Agenda Item 3

1055 Beverly Place

Staff Report

1055 Beverly Place

PROPOSED CARPORT

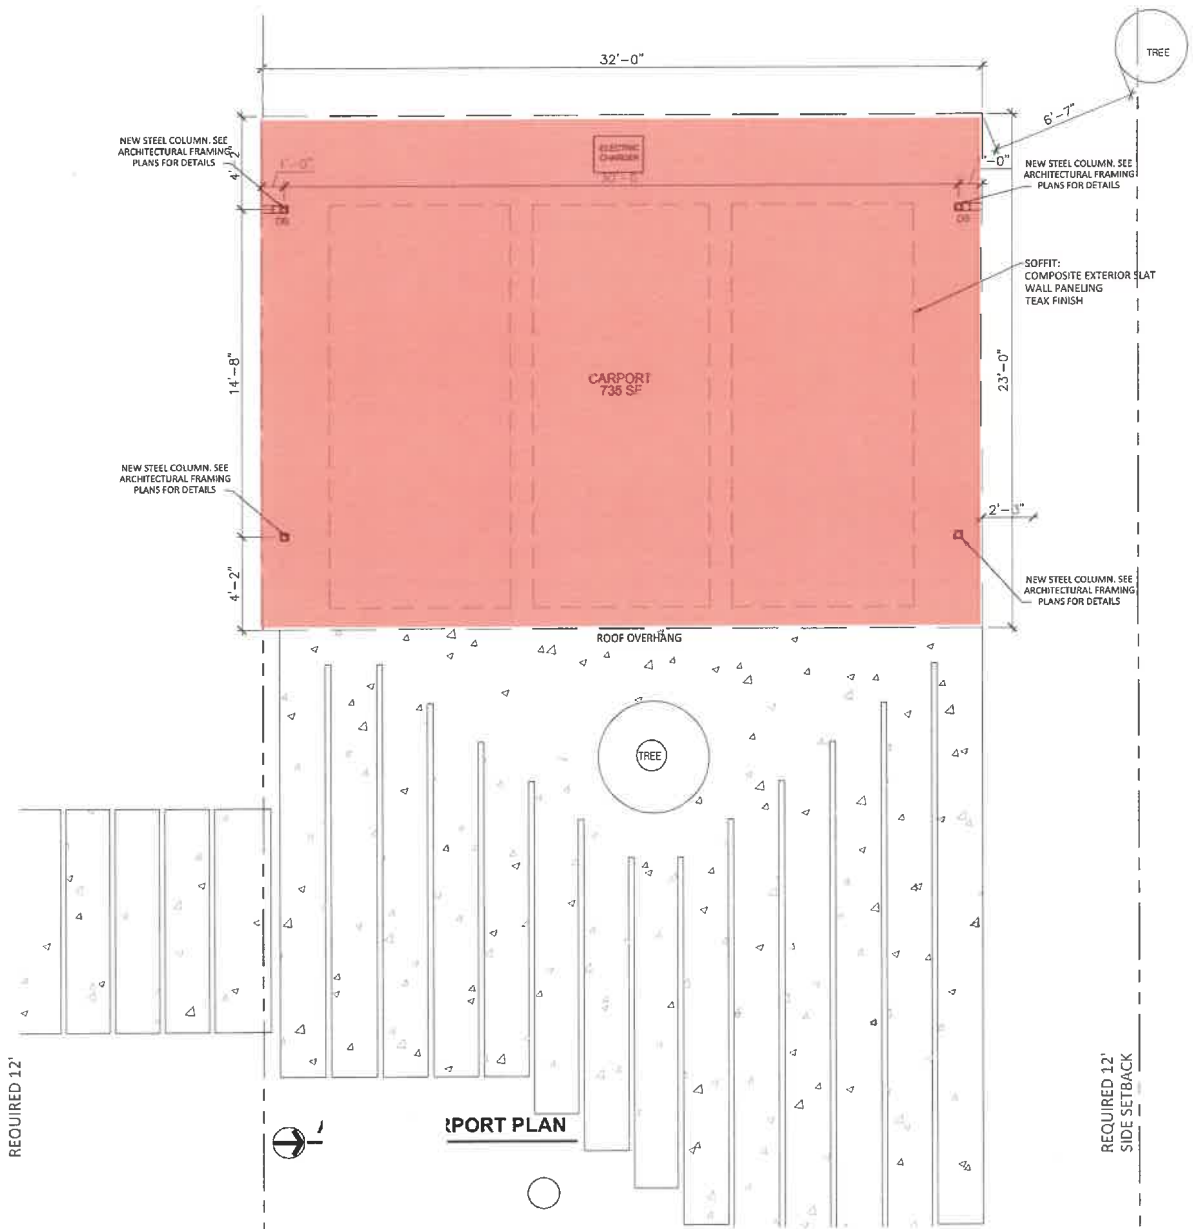
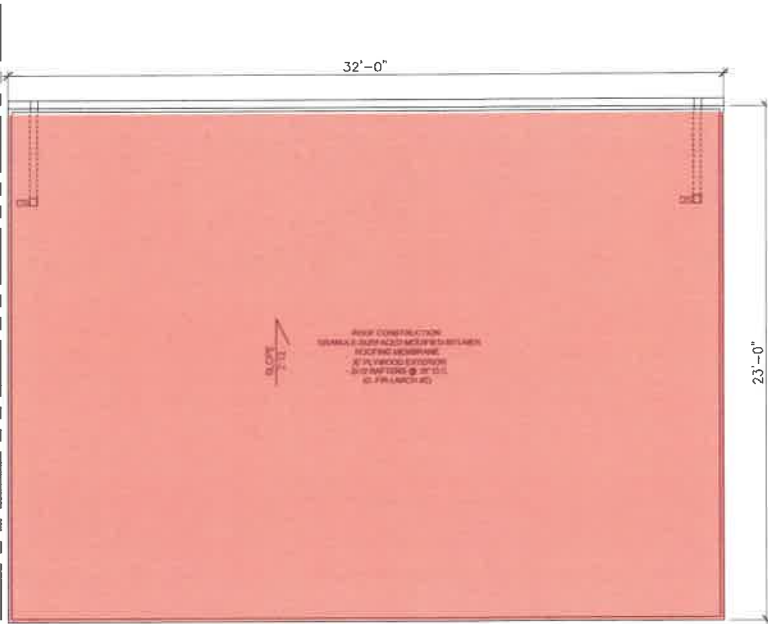
The location of the open carport near the west property line also presents the potential for the impact of headlights on private areas of the neighboring home

to the west at 222 Marion Avenue. As proposed, vehicles will enter the carport from the east creating the potential for ongoing impacts on the neighboring homes.

As noted above, an open carport is proposed. Carports are not common in this neighborhood. Headlight impacts and the potential for views of stored items, are concerns for neighboring property owners. Further consideration should be given to a design that could at least in part provide some additional screening of the interior of the carport.

Board input is requested on the carport.

1. Alternative designs for the front facing round window and the carport shall be submitted and will be subject to staff review in consultation with the Chairman. If appropriate, these elements shall be returned to the Board for final approval.
2. All modifications to the plans including those made in response to Board direction or discussion, or as the result of final design development, shall be clearly called out on the plan submitted for permit and a copy of the plan originally provided to the Board shall be attached for comparison purposes. Staff is directed to review any changes, in consultation with the Chairman as appropriate, to verify that any changes are consistent with the Board's approval prior to the issuance of any permits or if further Board review is required.

LANDSCAPE

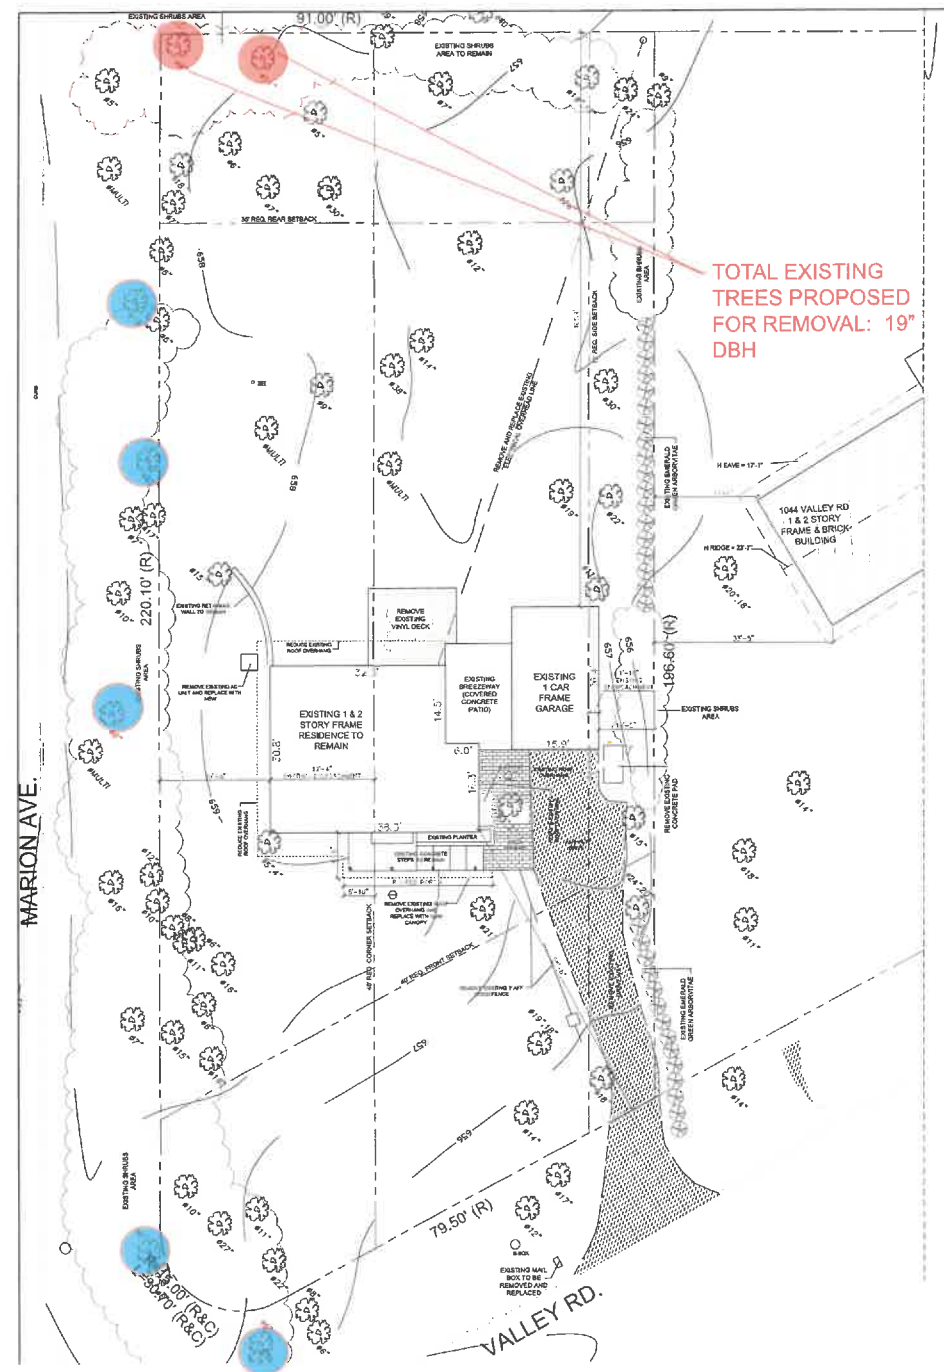
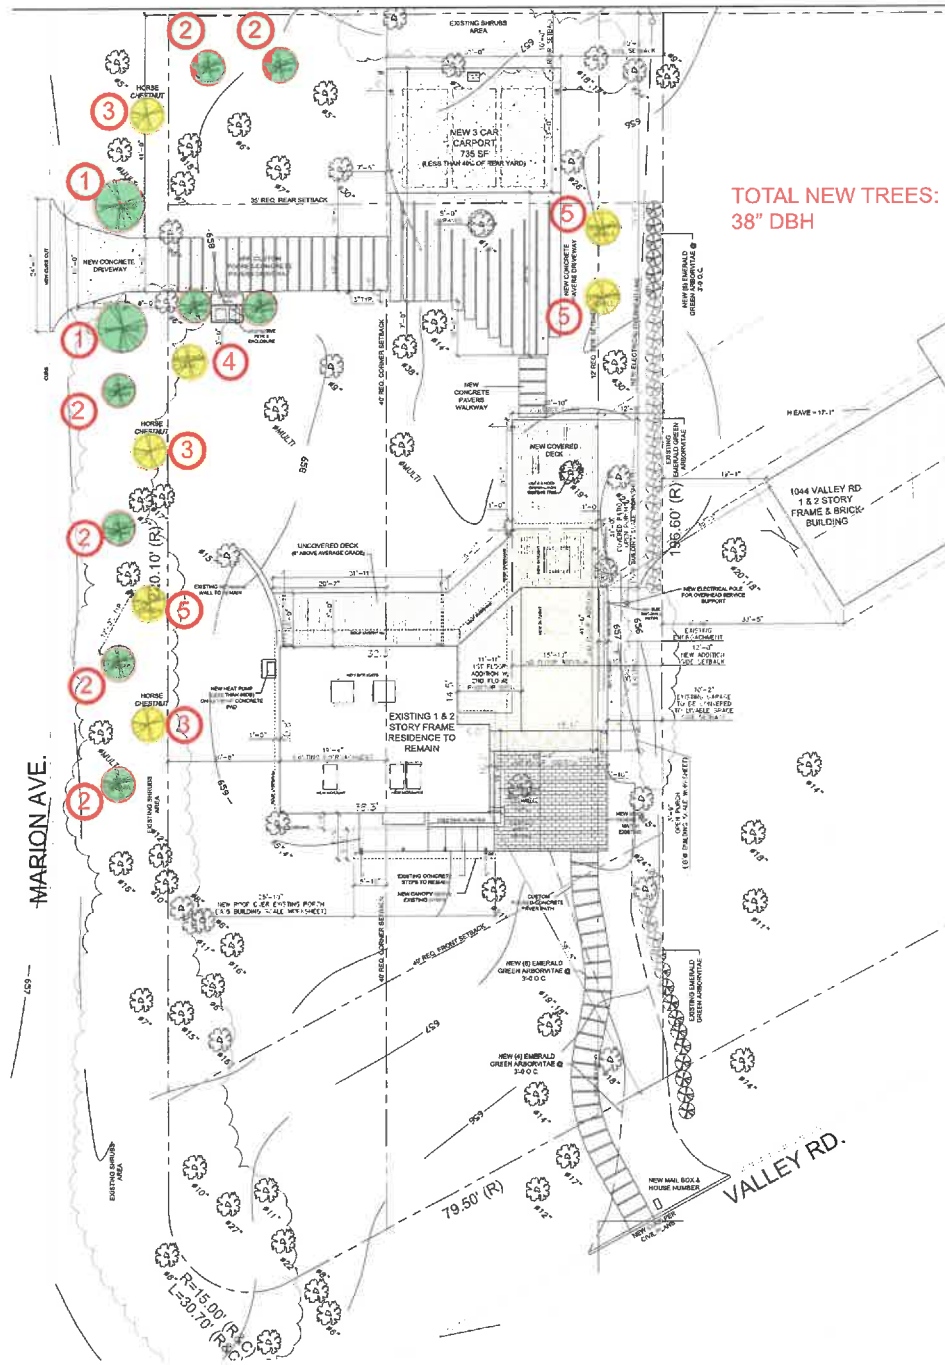
Although the petitioner's tree removal plan indicates that only two trees are proposed for removal, two Ash trees located in the southwest corner of the property, there appear to be four other trees that will need to be removed two of which are in excellent condition as noted below.

A pre and post construction tree care plan is recommended for other trees, near the proposed construction activity areas. The key trees that could benefit from treatment are listed below.

- b. A plan shall be submitted identifying the location of tree protection fencing to be installed prior to the start of construction and describing pre and post construction treatments proposed to increase the chances of long term survival of the trees.
